# Illustrated Parts List - IPL Update

**CS2260/CS2260WH**

## 1. Filter holder

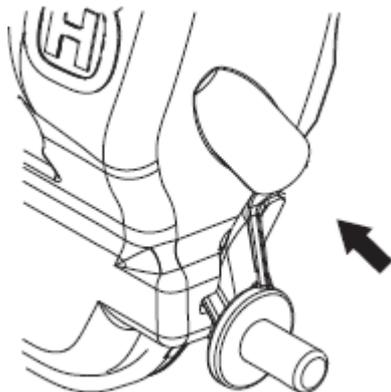
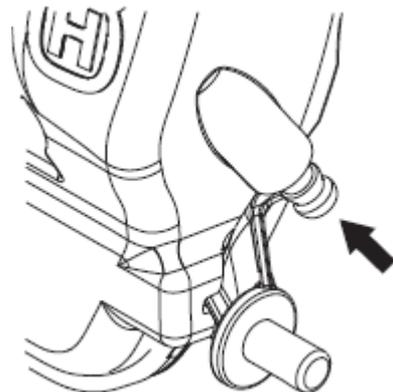
1. A new Filter holder, assy: 525 39 79-05 (standard) has been introduced. No nipple, hole removed to improve the startability.  
The same change has been made on Filter holder, assy: 525 39 79-06 (heat).
2. A new Hose kit 589 35 71-01 replace the Hose 587 64 54-02. The new kit can be used for both new and old models regardless of which generation of filter holder the user have.
3. A new Hose 587 64 54-04 added for the new filter holders without nipple.
